Application number: 2018/2342/P: 6 Albert Terrace Redevelopment Plan

**OBJECTION to Application for Planning Permission at 6 Albert Terrace by
Applicant, M. Golinsky.**

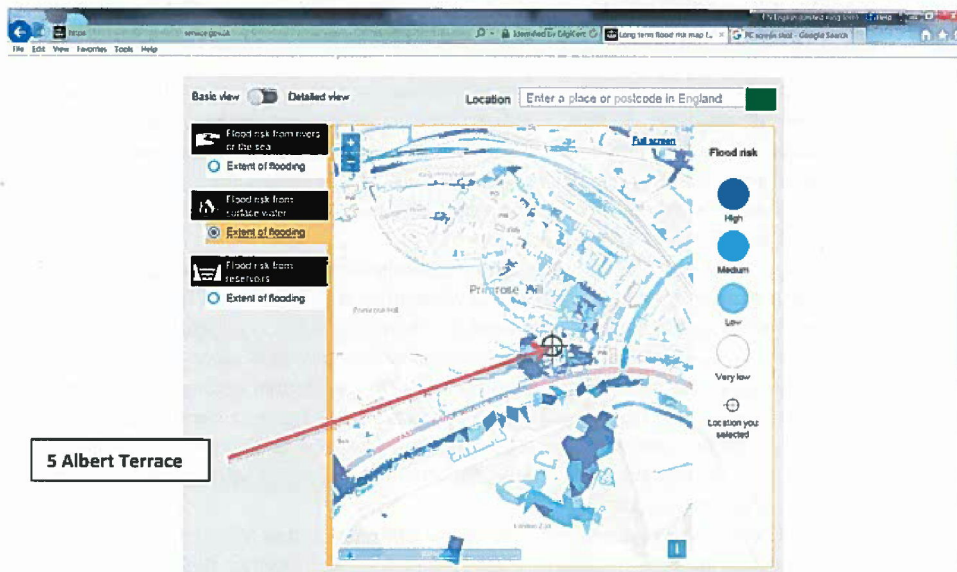
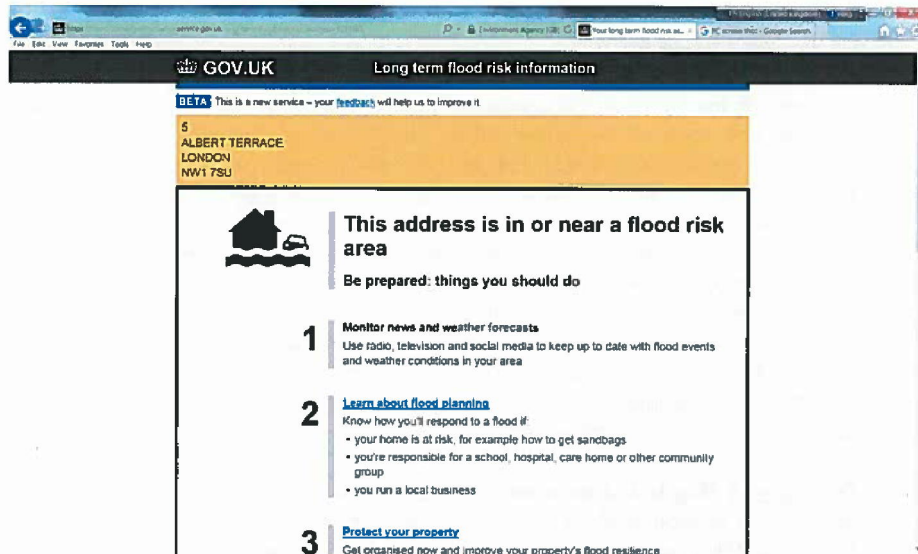
The Government Flood Risk below clearly shows 5 Albert Terrace to be within a 'Medium to High' flood risk area from surface water, and surrounded by High Risk areas directly in front and behind. This is despite the Applicant M Golinsky's assertions that the area is located in a low Flood Risk Zone 1.
